• Please make the following corrections to "A Delayed-Trigger Accessory for Oscilloscopes" (January 1988). On page 22, the first paragraph under "Checkout & Use" should read: "Then touch the 'hot' meter lead to pin 8 of the IC1 socket, pin 14 of the IC2 socket and pin 16 of the IC3 socket . . . . Touching the hot lead to pin 4 of the IC1 socket should yield a reading

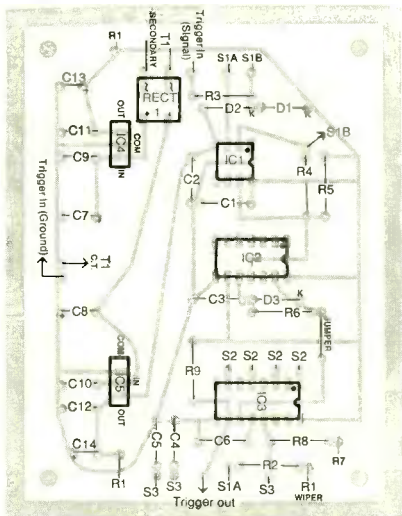
of -15 volts." Turn the page upside-down for correct orientation of the photos in Fig. 1. The trace in (A), now lower-right, is triggered on the rising edge of the square pulse. The manufacturer of the ICM7250 chip is Intersil. Finally, use the corrected wiring diagram shown here instead of the one shown in Fig. 6.
